RICHMOND COMMUNITY SCHOOL
Richmond High School: Mechanical Modernization Project
LWC Commission No. 20104.02

ADDENDUM #04
October 5, 2021

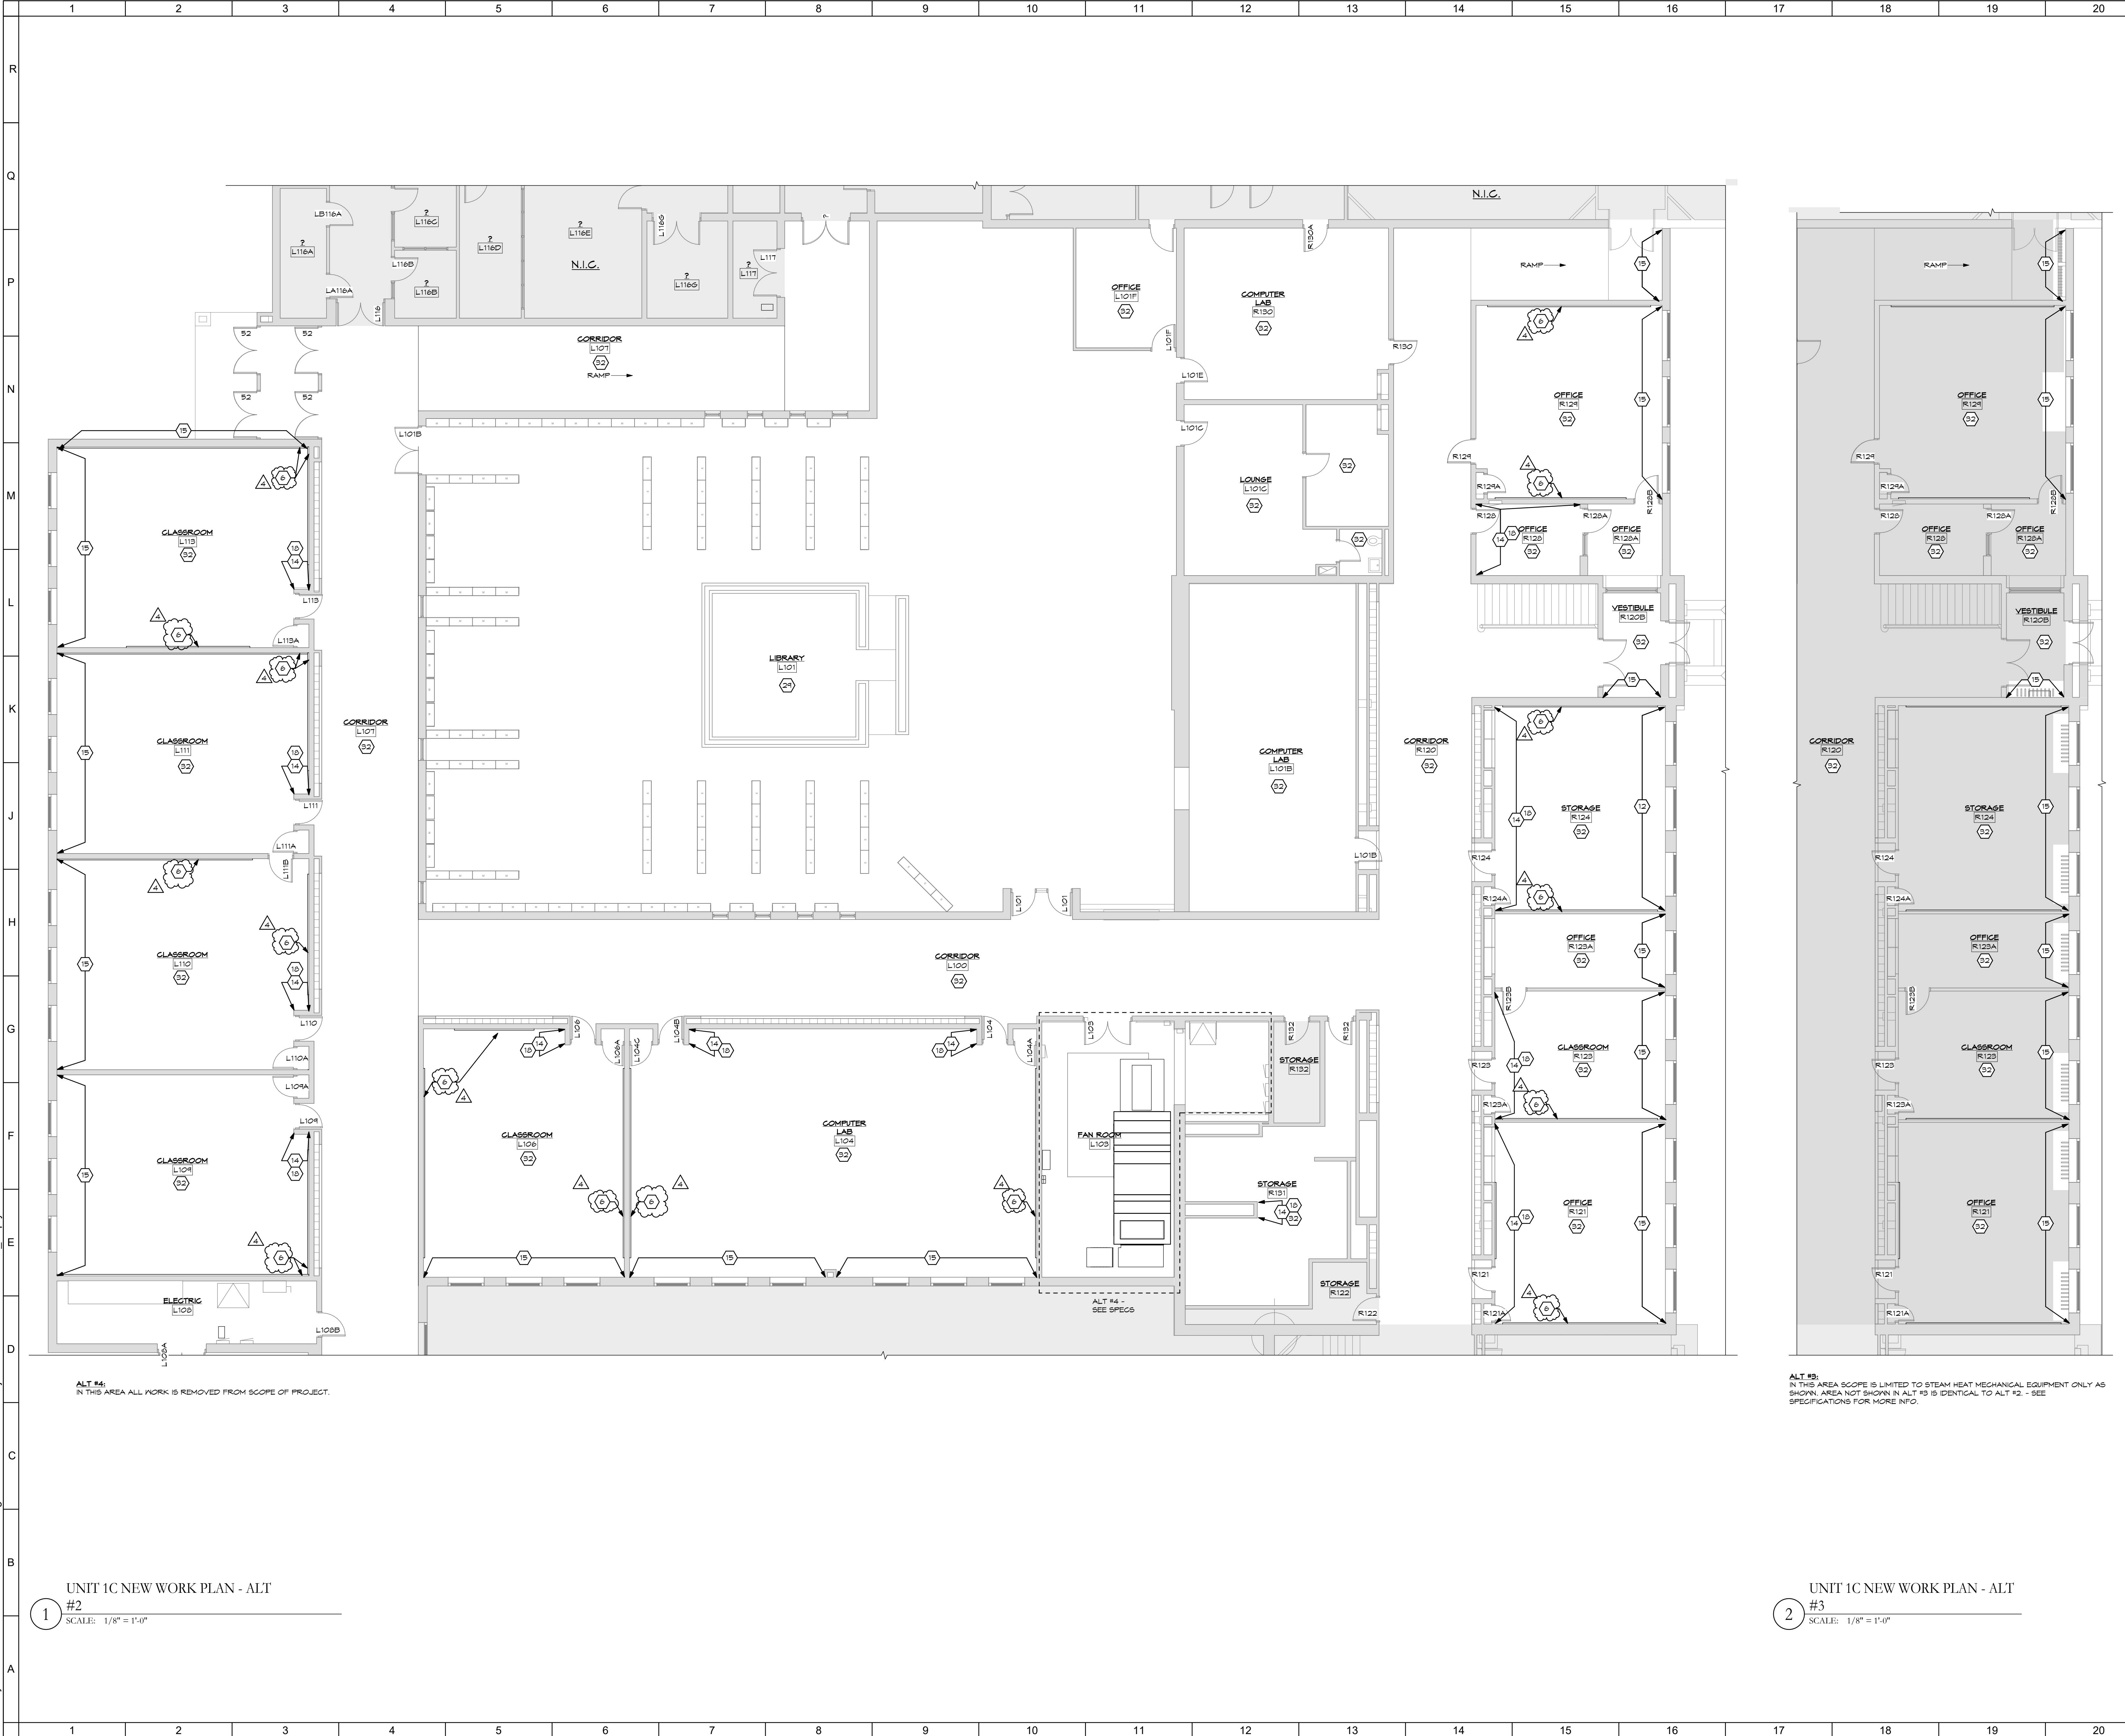
- A. Revised Key Note at Markerboards.

3 NEW MARKER BOARD OVER EXISTING CHALK BOARD
SCALE: 12" = 1'-0"

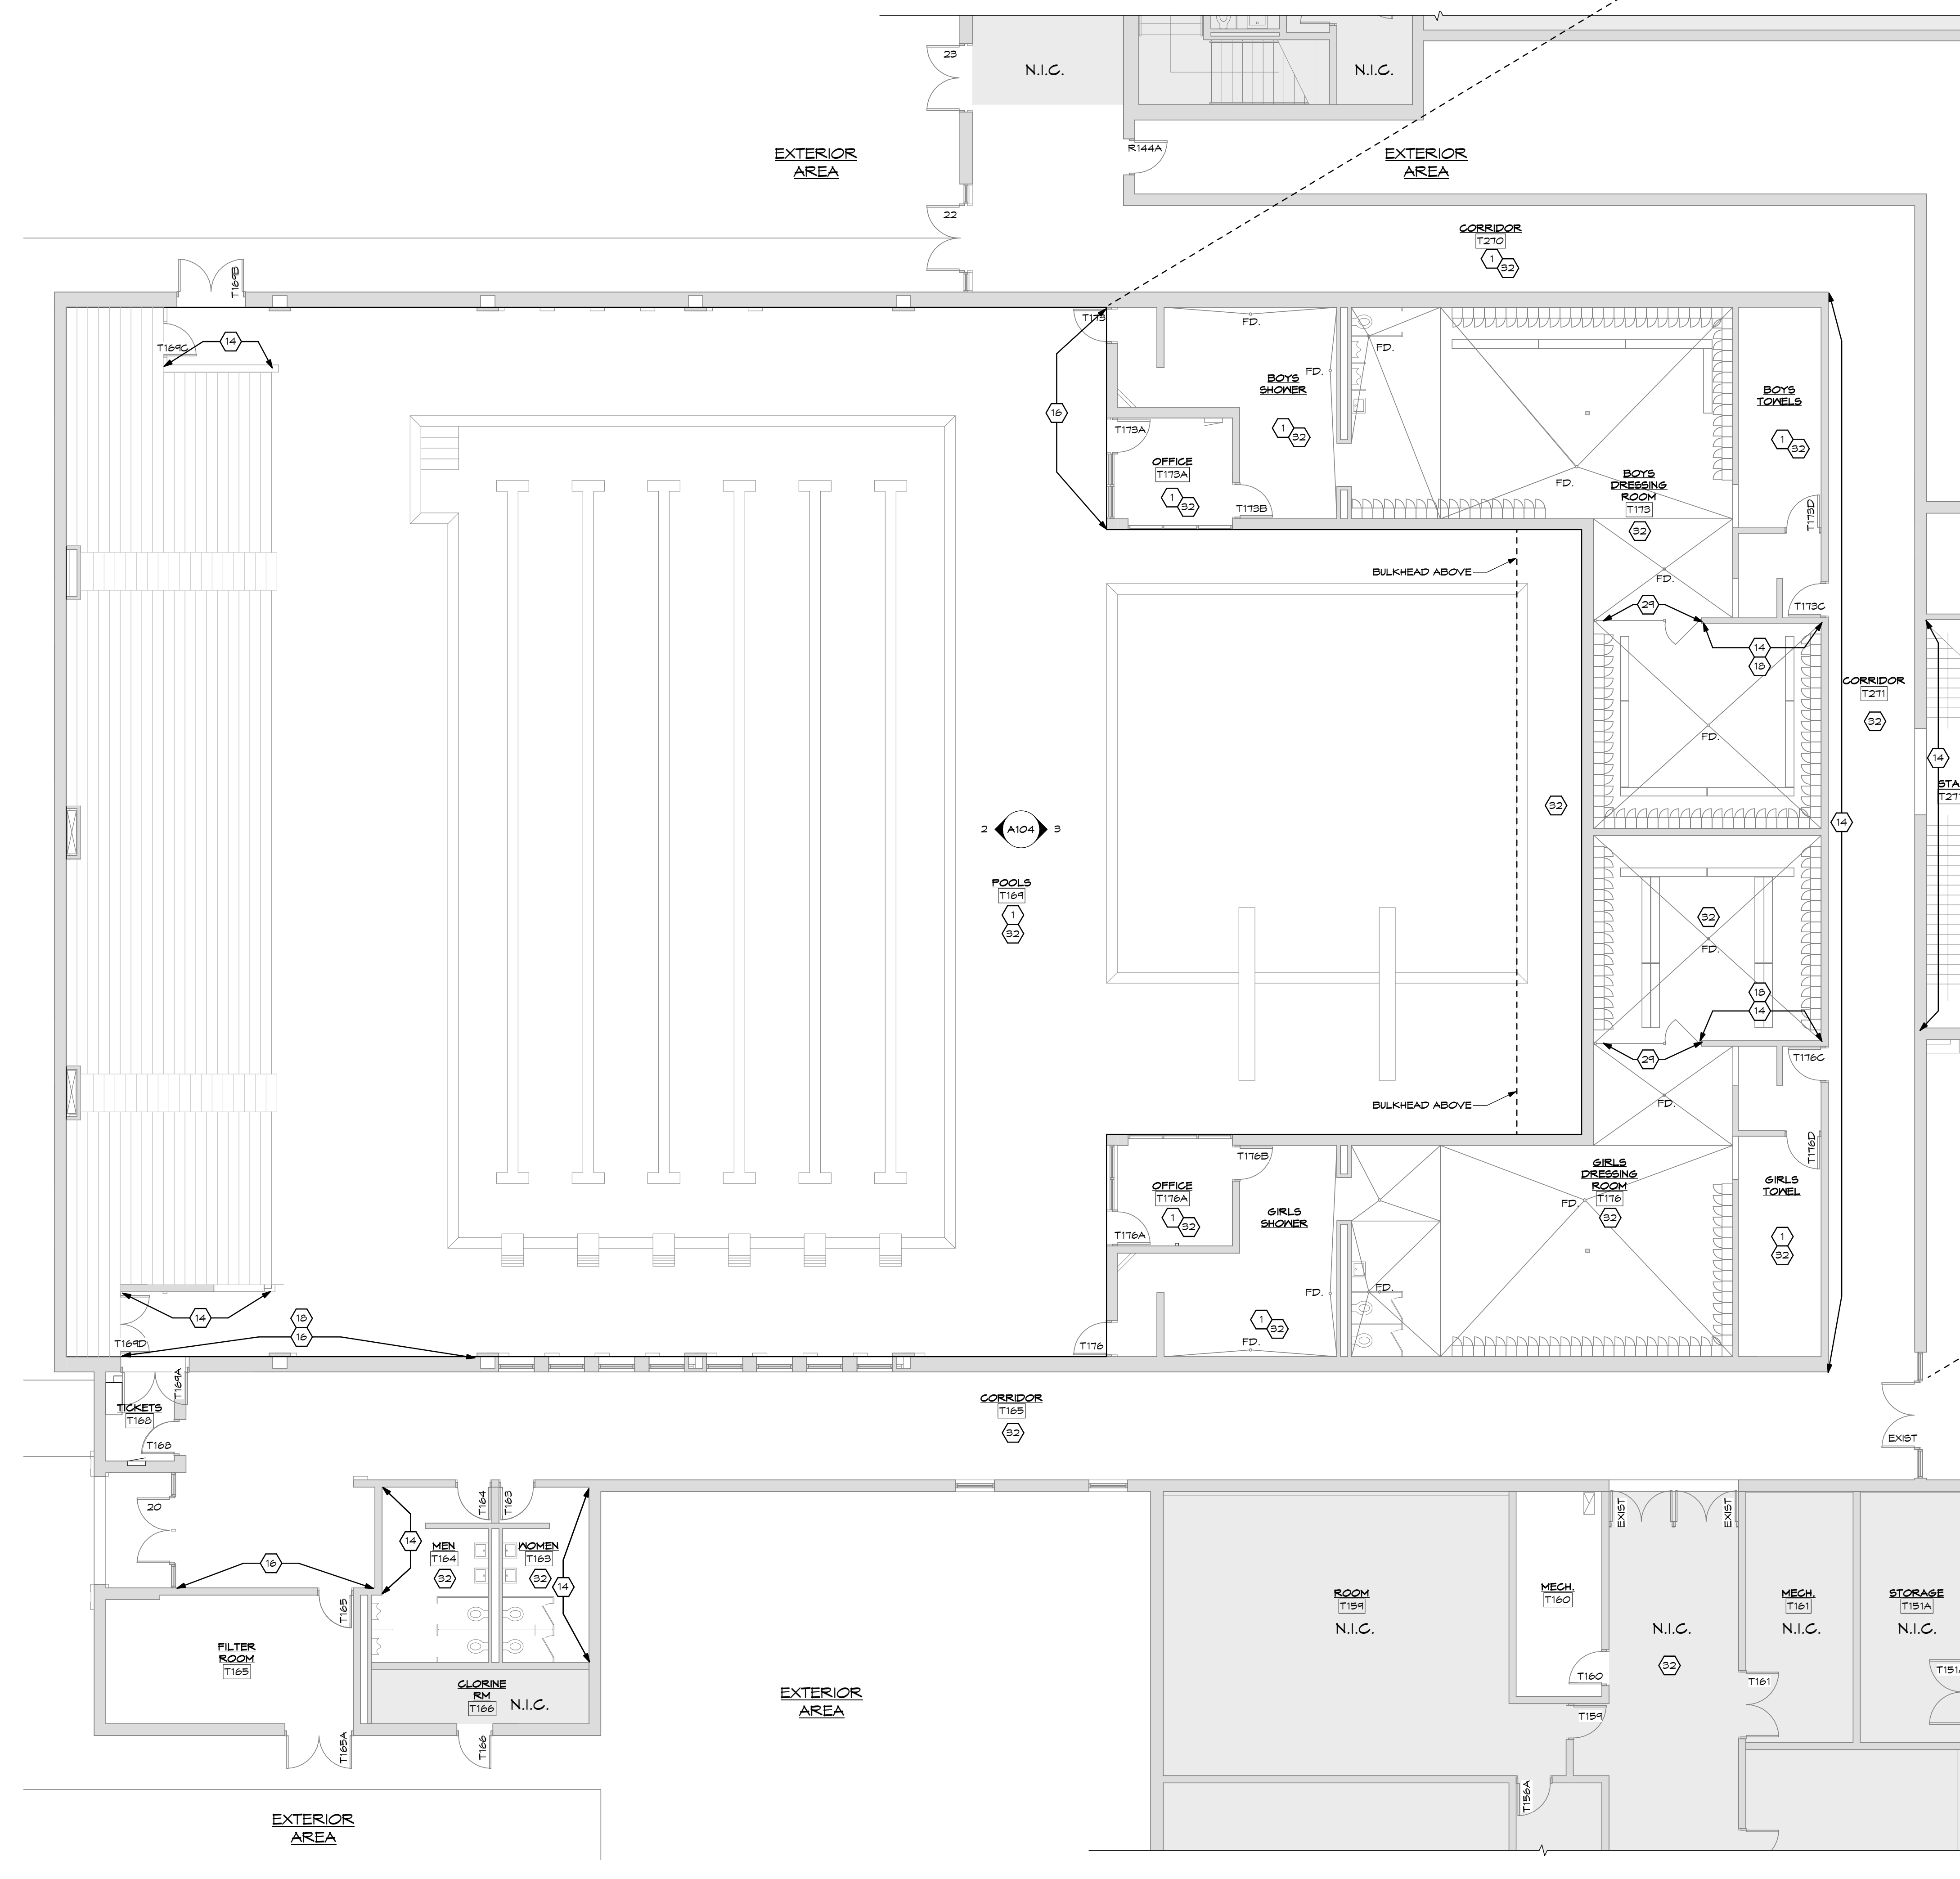
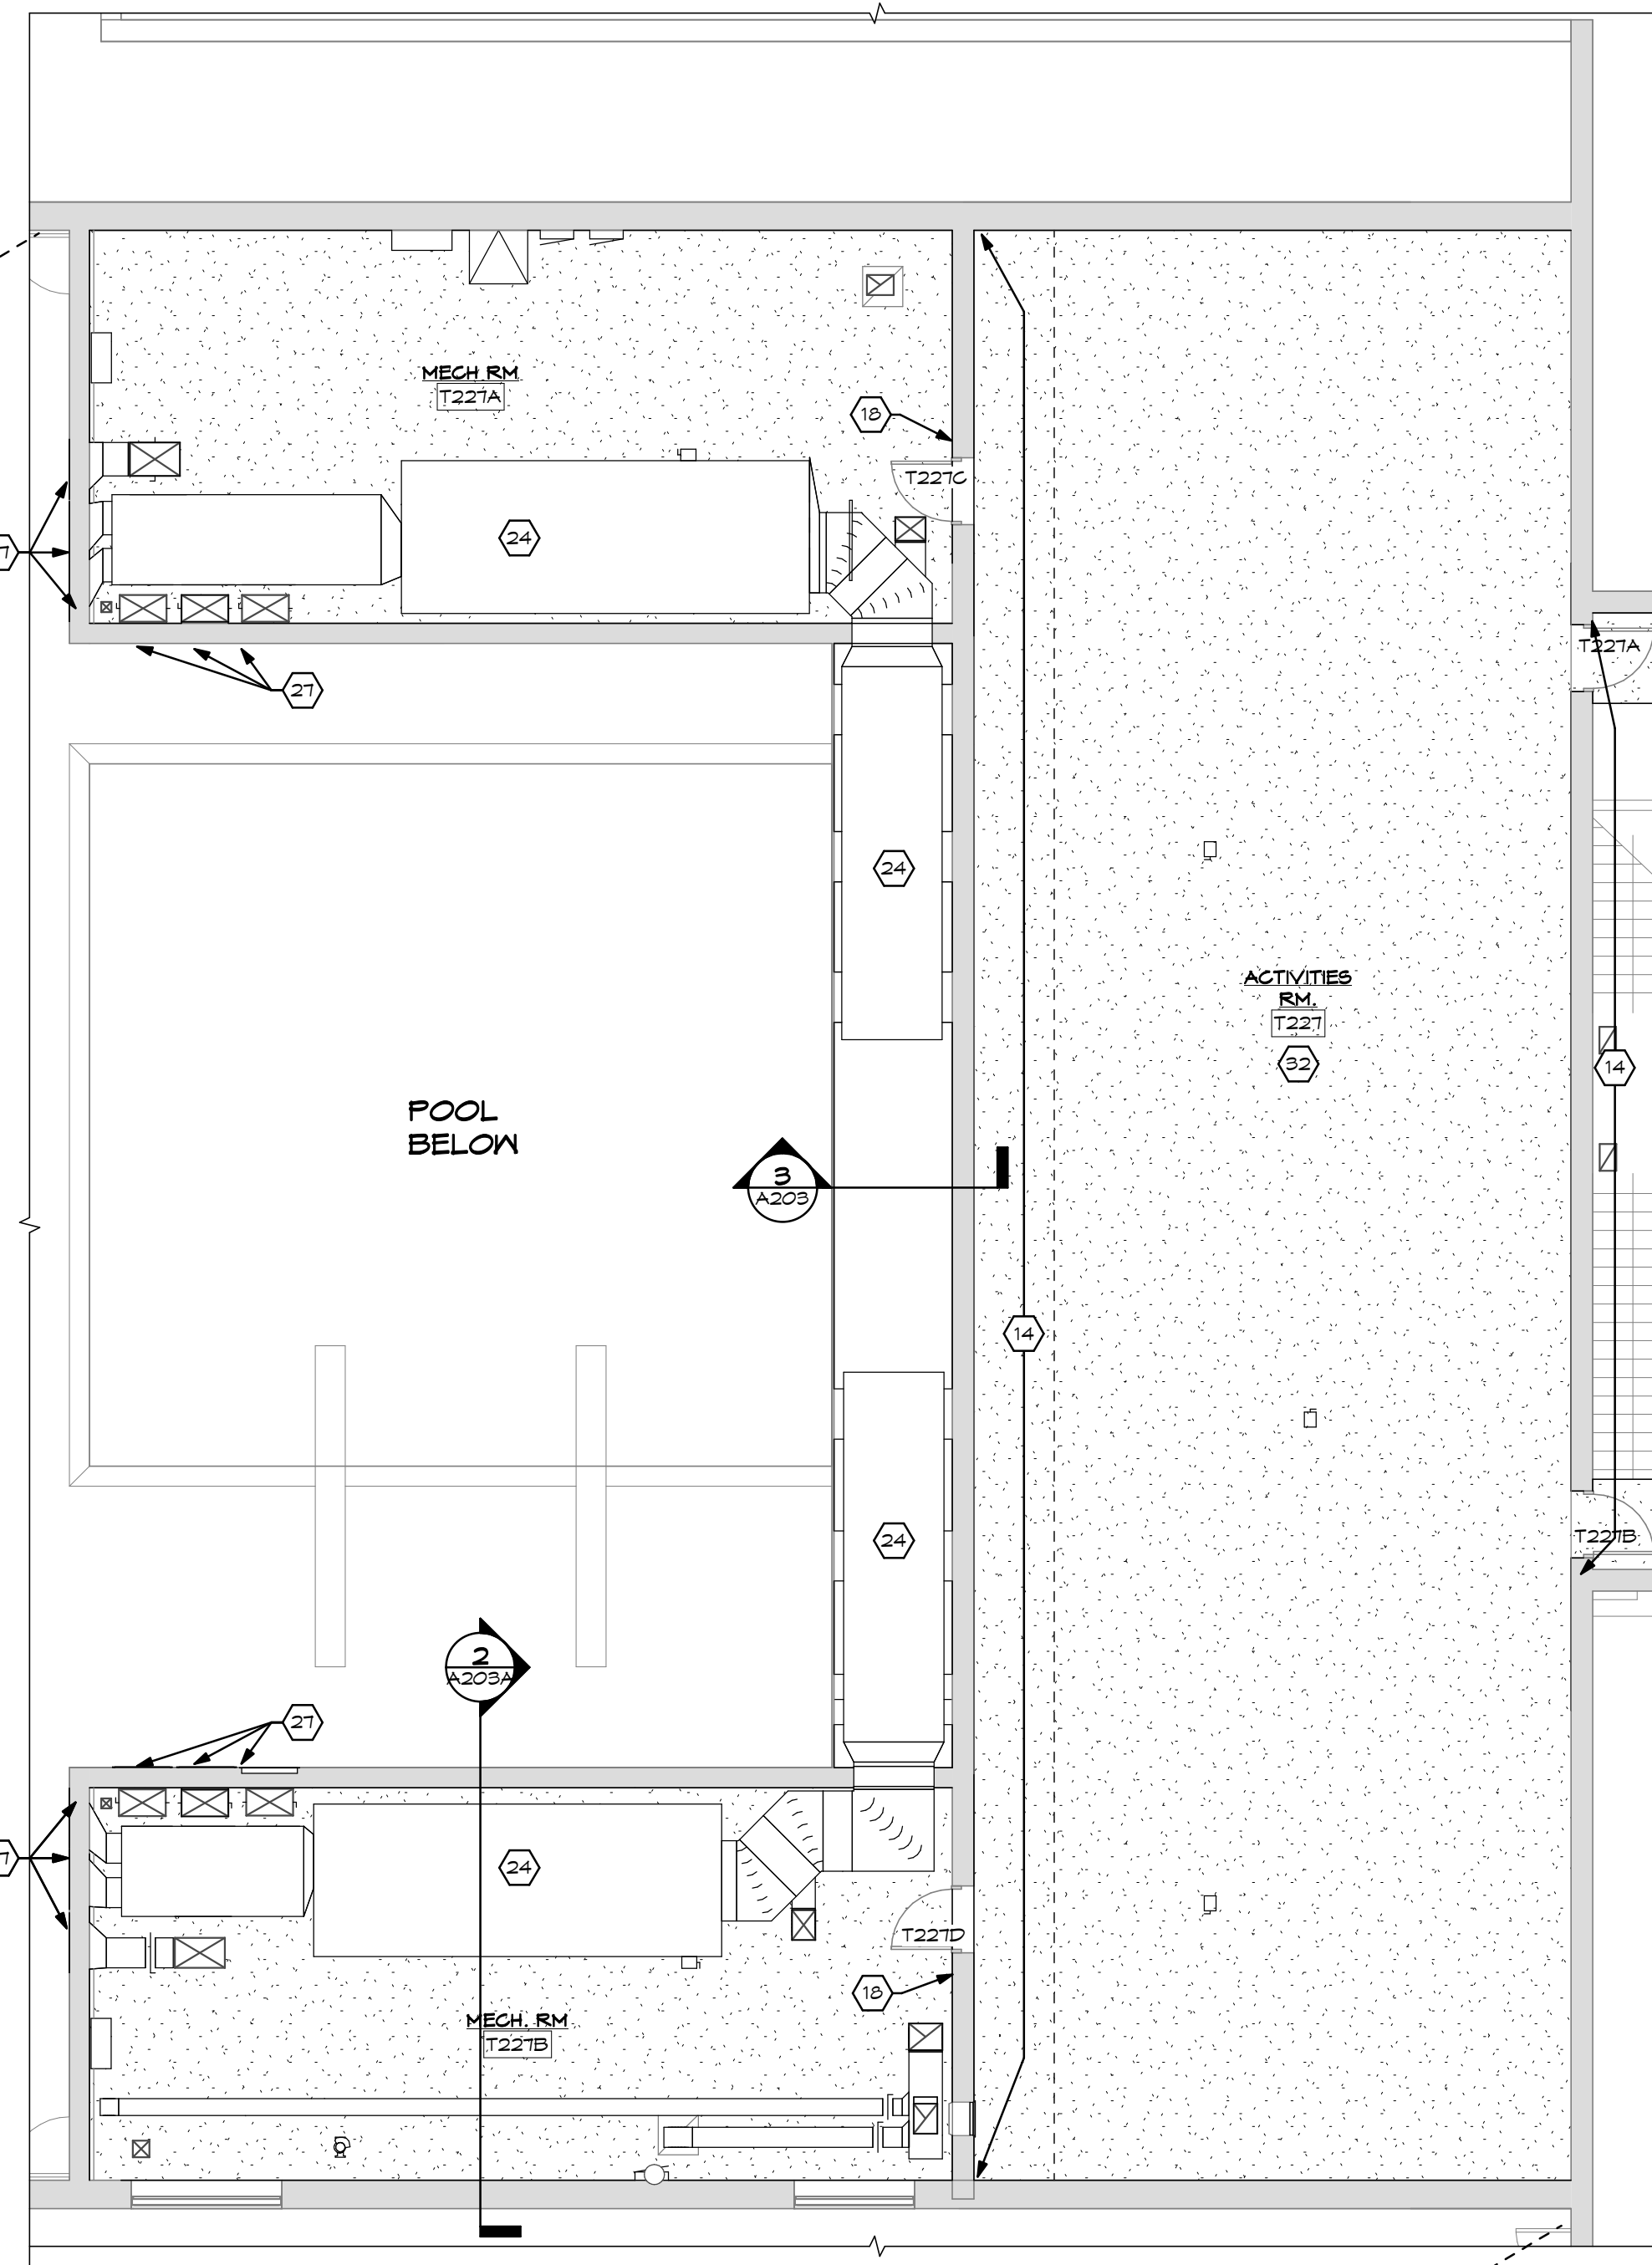
ITEM NO.1 Drawing A102A

- A. Revised Key Note at Markerboards

| RFI Number | Date IN | Date OUT | Due Date | Description/Response | Sheet/Spec Reference | PCO Number | CO Number |
|--------------------------|---------|----------|----------|---|----------------------|------------|-----------|
| Whisenhunt 001 | 10/1/21 | 10/5/21 | | Sheet A102...looks to me like the marker boards that are intended for Alt 2 are noted as Note 1 on the plan. Sheet notes show marker boards are note 6. Am I seeing this right? | | | |

| RFI Number | Date IN | Date OUT | Due Date | Description/Response | Sheet/Spec Reference | PCO Number | CO Number |
|--------------------------|---------|----------|----------|---|----------------------|------------|-----------|
| | | | | ANSWER: Replacement of chalkboard with markerboards is NOT part of the Base Bid. The cost to replace chalkboards with markerboards should be included in Alternate #2. The drawings have been revised to clarify this intent. | | | |
